Urgent Field Safety Notice
WiSE CRT Electrode-Catheter Model 1000

Urgent Field Safety Notice (FSN)
WiSE CRT Electrode-Catheter Model 1000
Receiver Electrode Detachment Issue

Appendix B: Amended Electrode Delivery System Instructions for Use

Figure 1: Electrode Detached - Orange Indicator Circle (boss) at Proximal Side of Handle

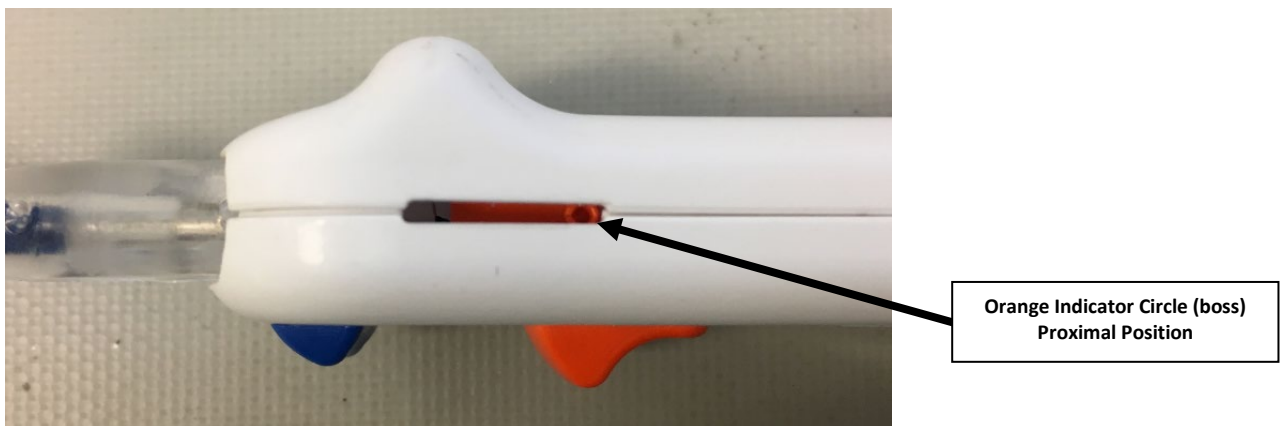
However, in the event that, after following the required IFU step of pushing the detach button (orange button) forward, there is no indication of detachment (viewing port color did not change from green to orange) and it is uncertain whether or not the Electrode has successfully detached, you may either:

- **Follow the steps in the IFU to remove the Electrode Delivery System; or**
 - **Complete the following sequence of steps to visually assess detachment, and if indicated, perform a manual Electrode detachment.**
1. Visual Assessment: On the catheter handle, examine the side port and determine the position of the orange circle (also referred to as “boss”). If it is fully proximal, as shown below in Figure 1, indicating that the Electrode is detached, proceed to release the electrode from the sheath per the IFU. If the “boss” is not proximal (as shown in Figure 2), indicating that the Electrode is not detached, proceed to step 2 below, Manual Detach

Figure 3: Electrode Manual Release

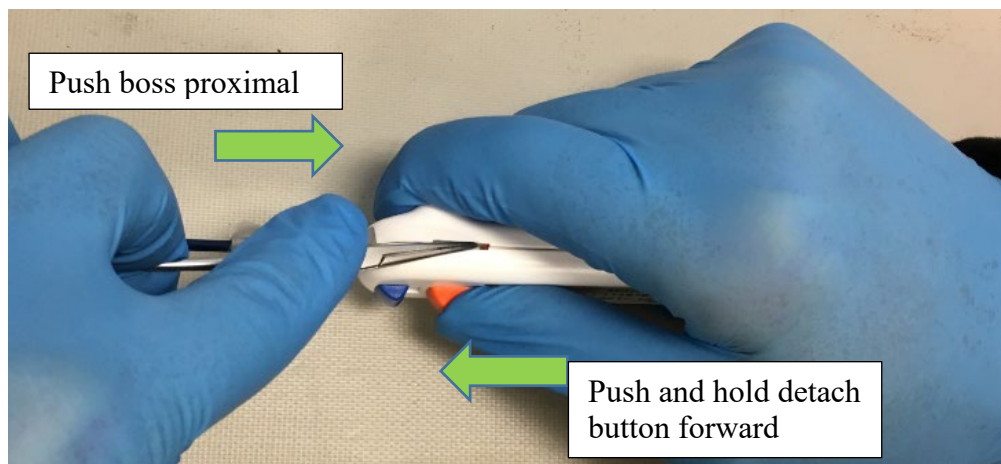
2. Manual Detach: While maintaining the position of the Electrode and Delivery Sheath, as shown below in **Figure 3**, push and hold the orange detach button forward and at the same time insert a tool like a forceps or similar into the side port to engage the “boss” (orange circle), and slide the “boss” proximal. The distal tip of the tool should be approximately 1mm diameter and 7mm long to engage the boss feature. Afterwards, release detach button and verify the orange circle (boss) remains fully proximal. If proximal (as shown above in Figure 1), proceed to release the electrode from the sheath per the IFU. If the Orange Indicator Boss is not proximal (as shown in Figure 2, follow the steps in the IFU to remove the Electrode Delivery System.
